Mr. Richard Knowland, Senior Planner
February 16, 2001
Page 11

**Portland International Jetport - Phase I Parking Garage Improvements
Planning Board Application - Response to Comments**

Re: Portland International Jetport, Phase I Parking Garage
Application for Major Site Plan Approval

SURVEY PLOT PLAN
 OF:
LAND TO BE CONVEYED
 WESTBROOK STREET
 PORTLAND, MAINE
 FOR:
DUFRESNE-HENRY, INC.
 CONSULTING ENGINEERS
 PORTLAND, ME 04101

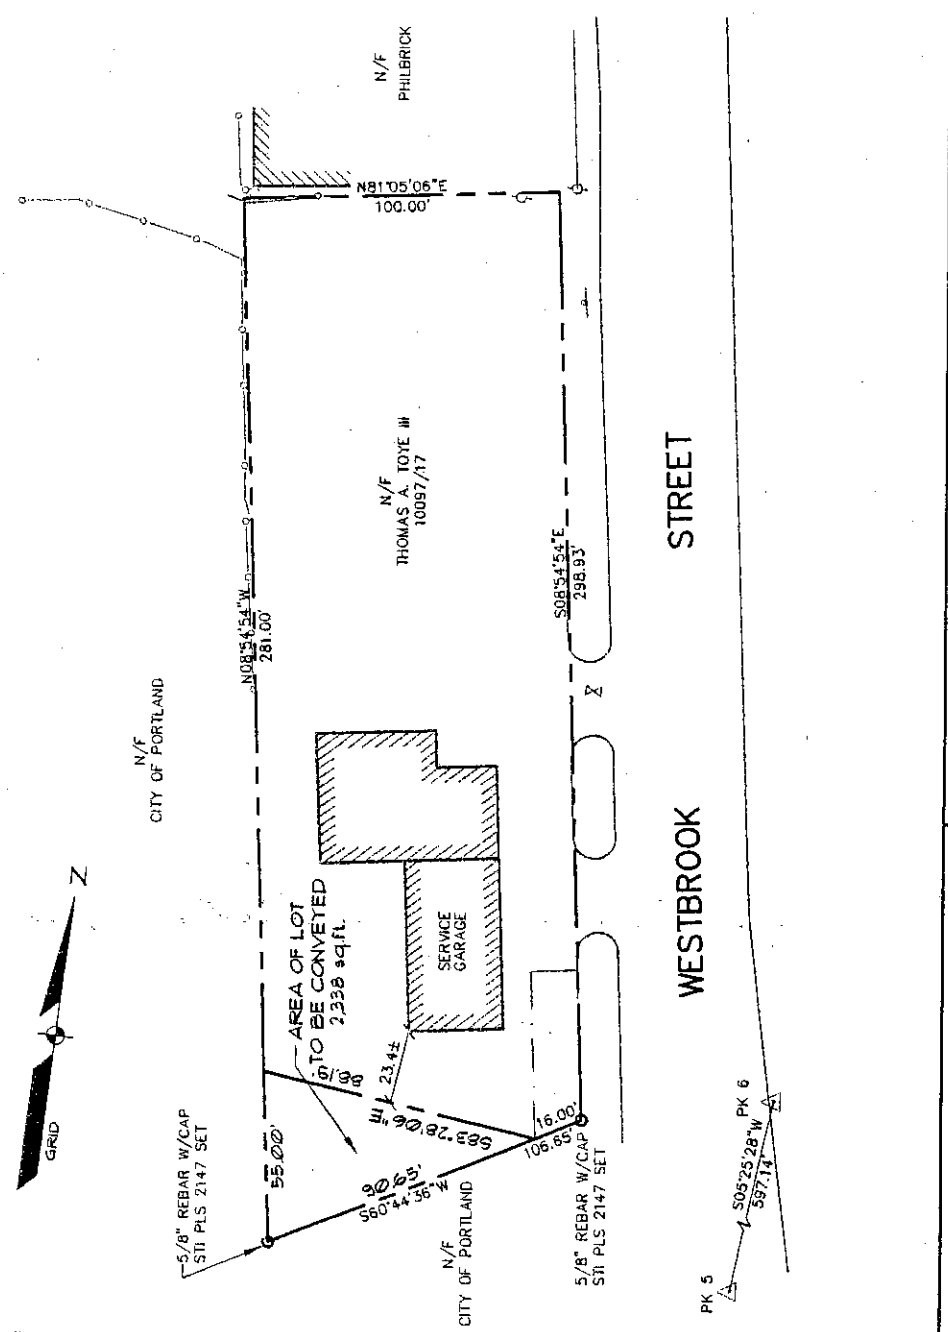
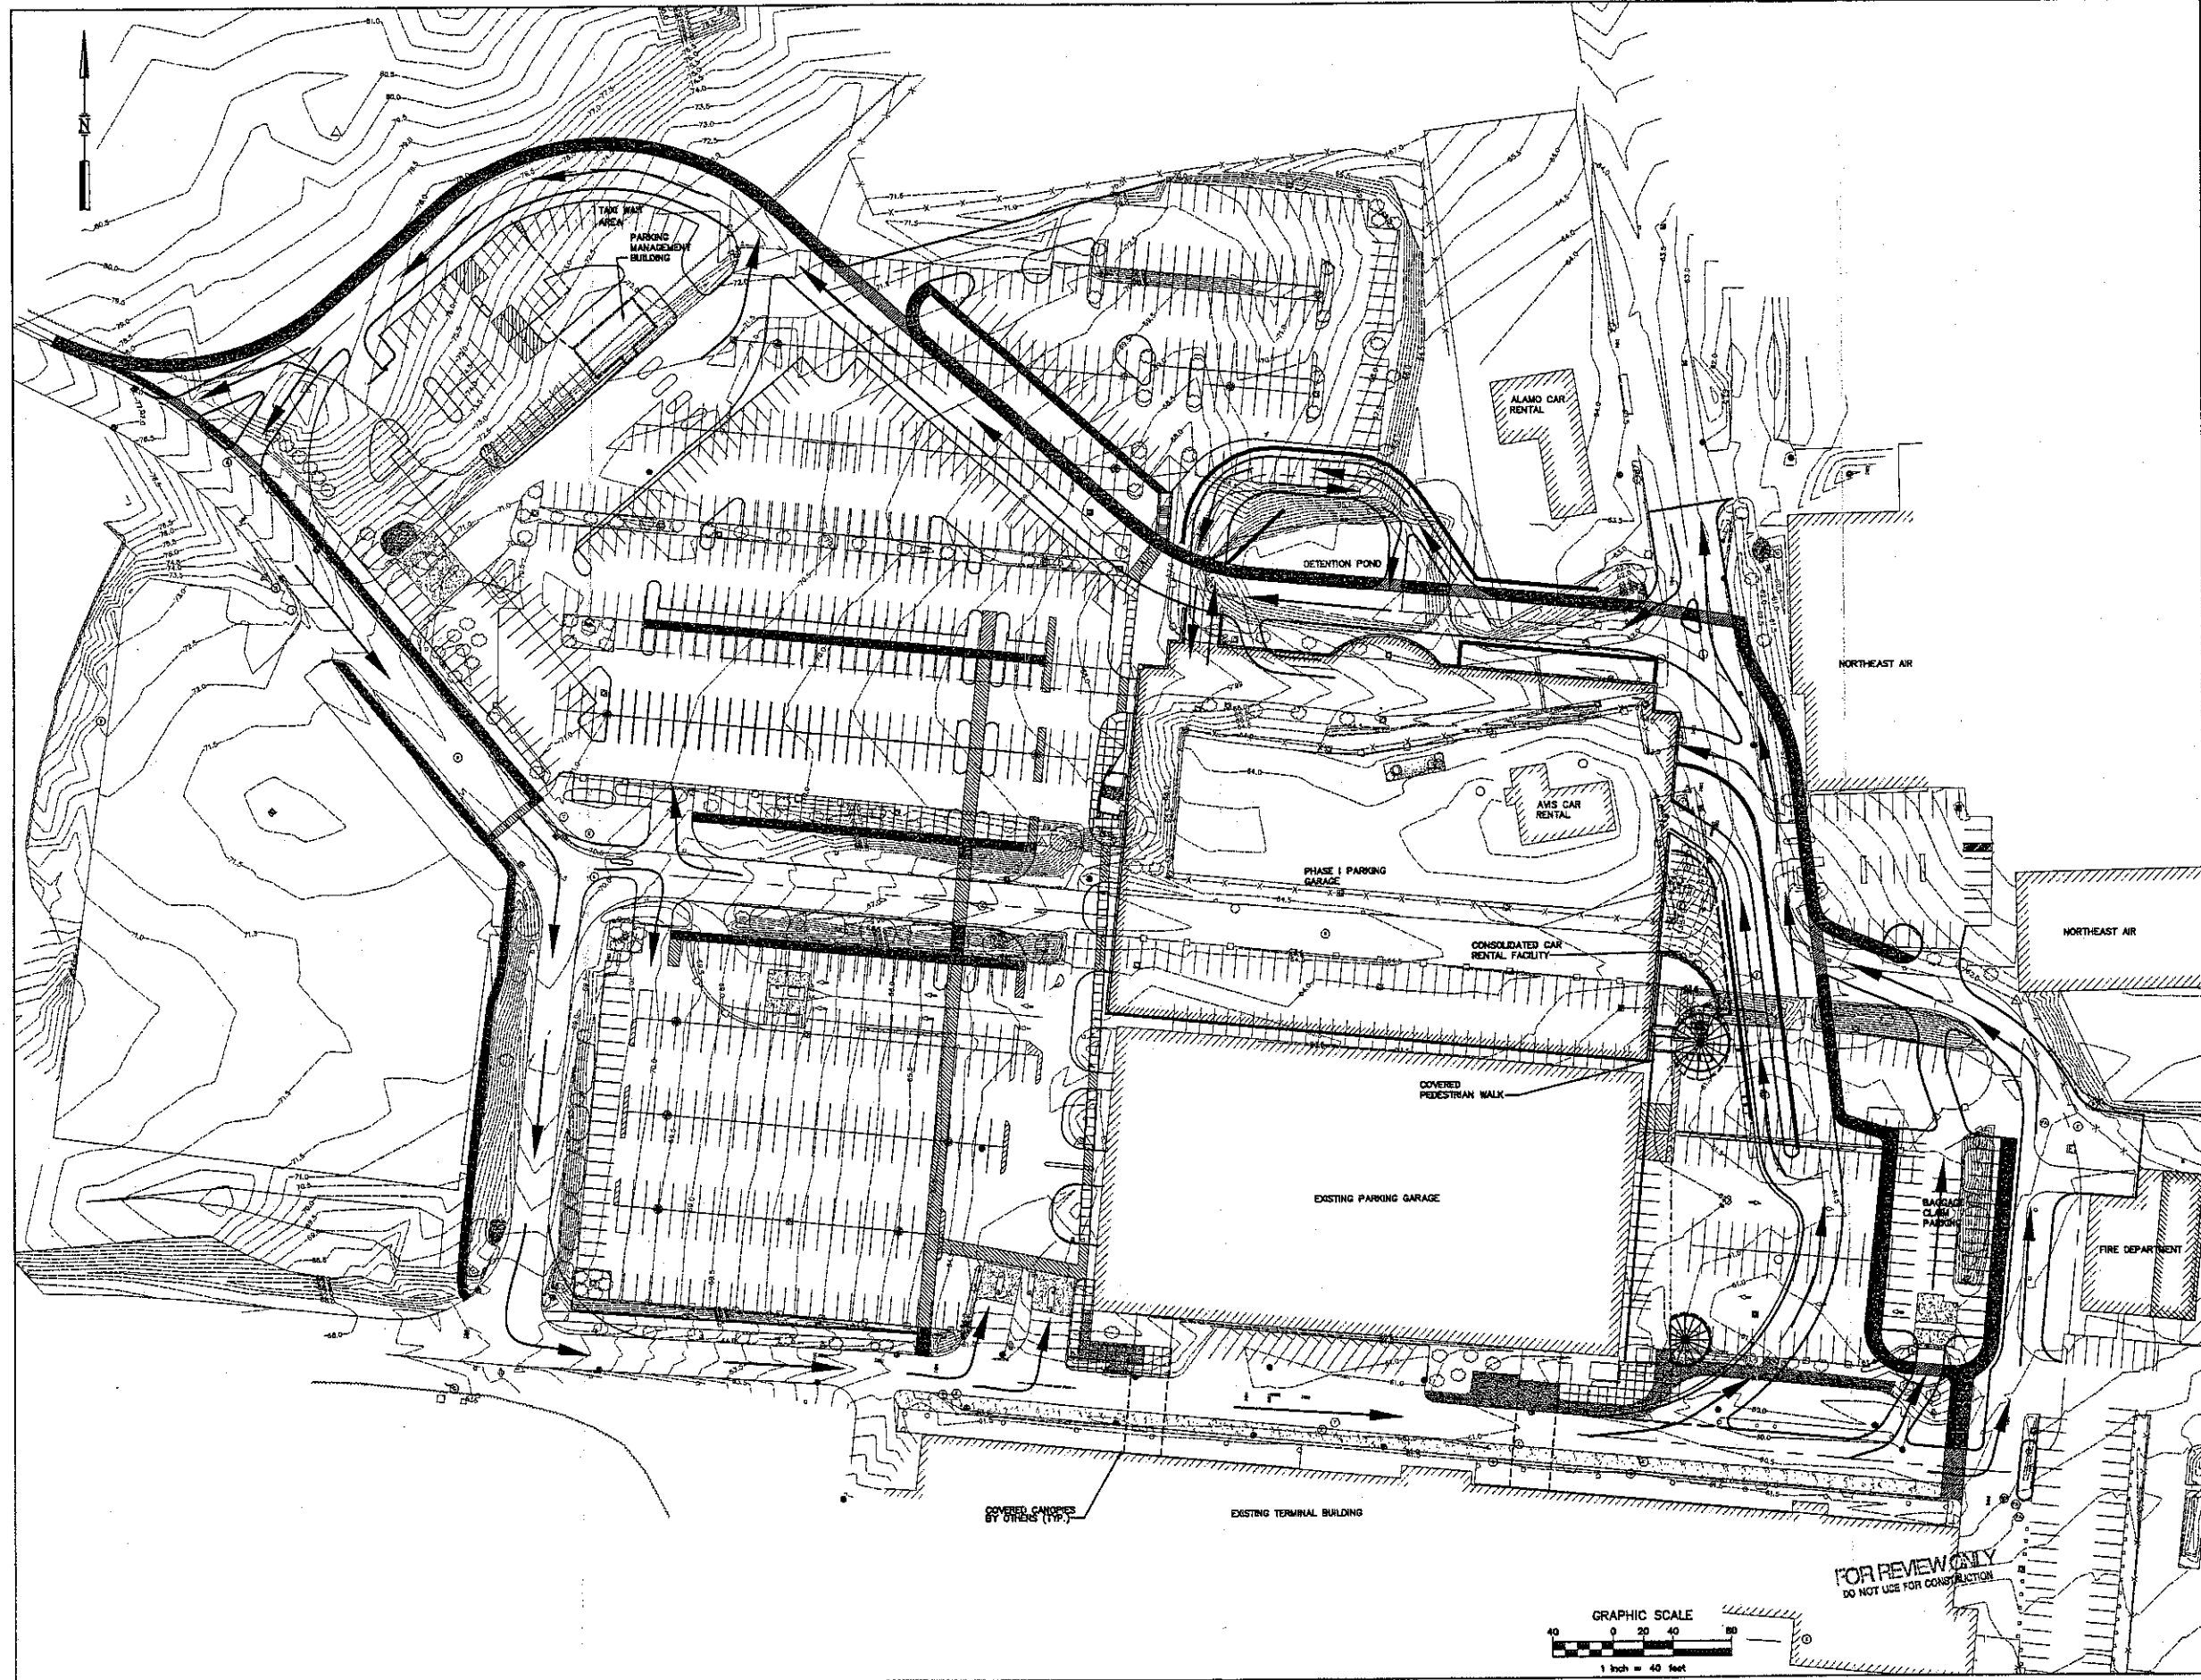
- ▶ **Is the property plan provided as Exhibit "A" a boundary survey?**

The Exhibit a plan details all of the properties under control by the airport. However, it is not considered a boundary survey although the property lines shown on the drawing are based on the deed descriptions. A boundary survey of the Alamo lot which is the only property affected by the proposed improvements, see Attachment I.

Site Sections

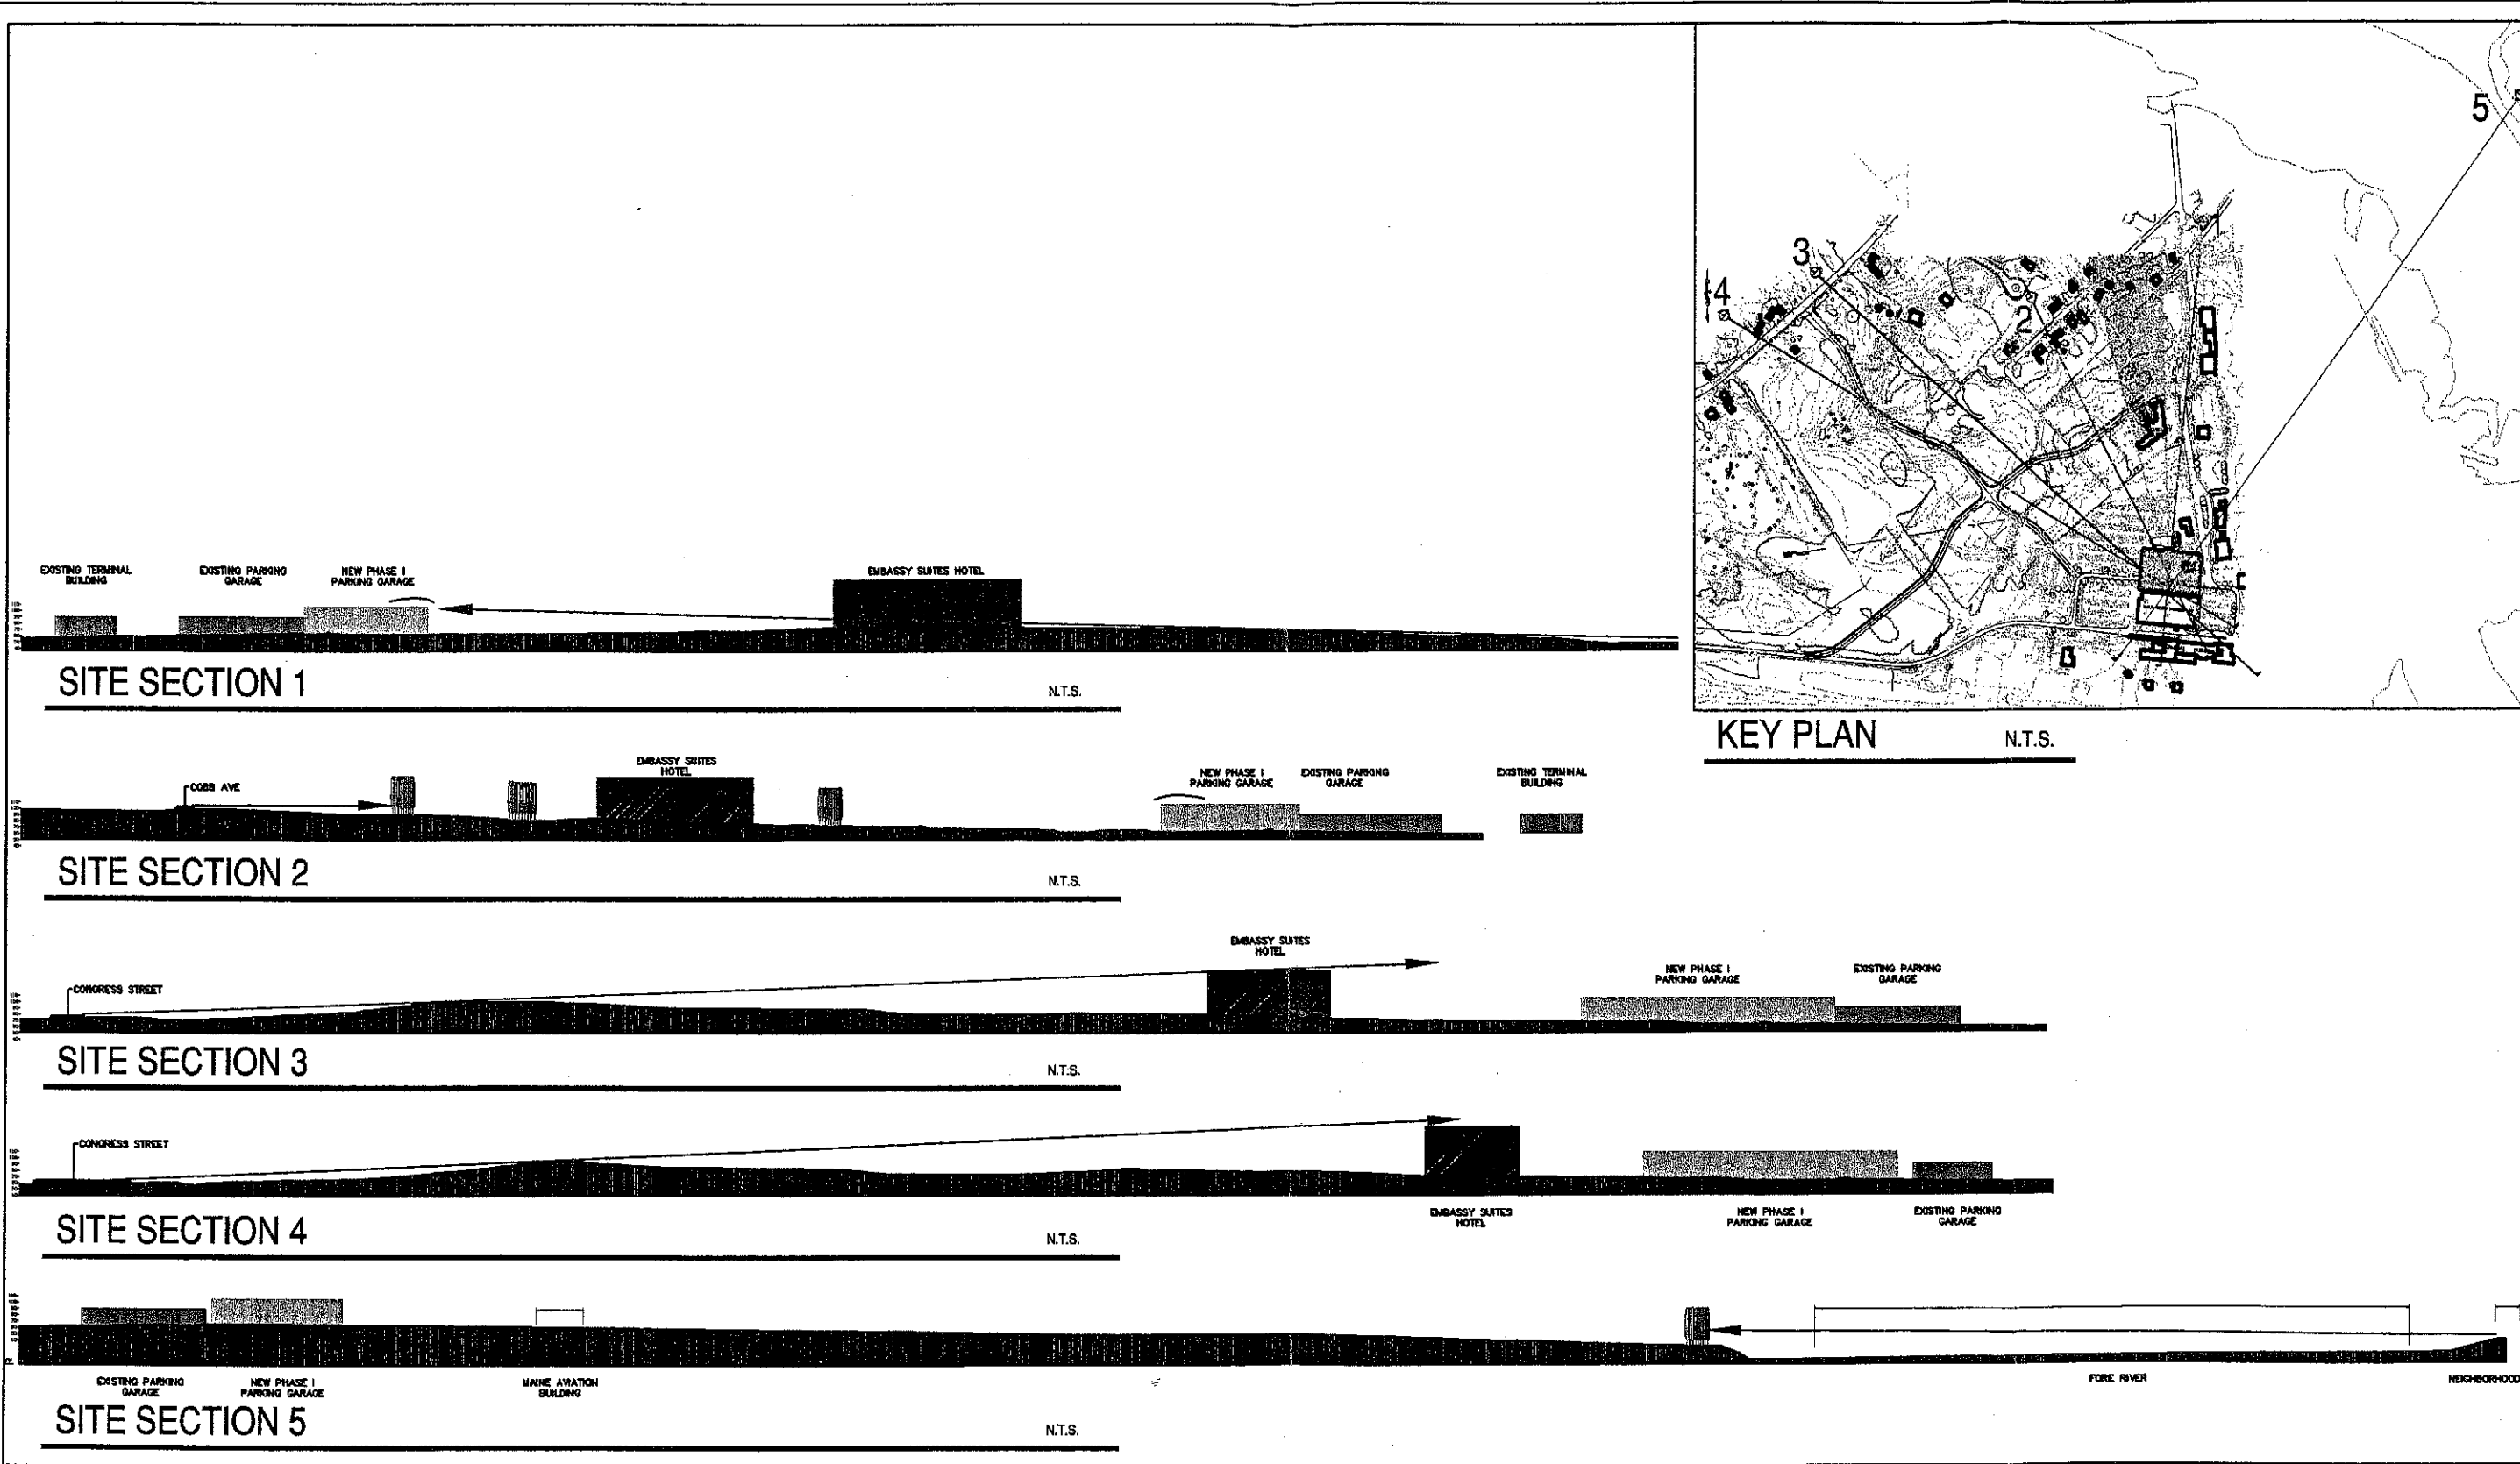
- ▶ **Provide a site section showing the relative height of the Phase I Garage.**

A site section from the September 2000 Parking Master Plan is included as Attachment K.
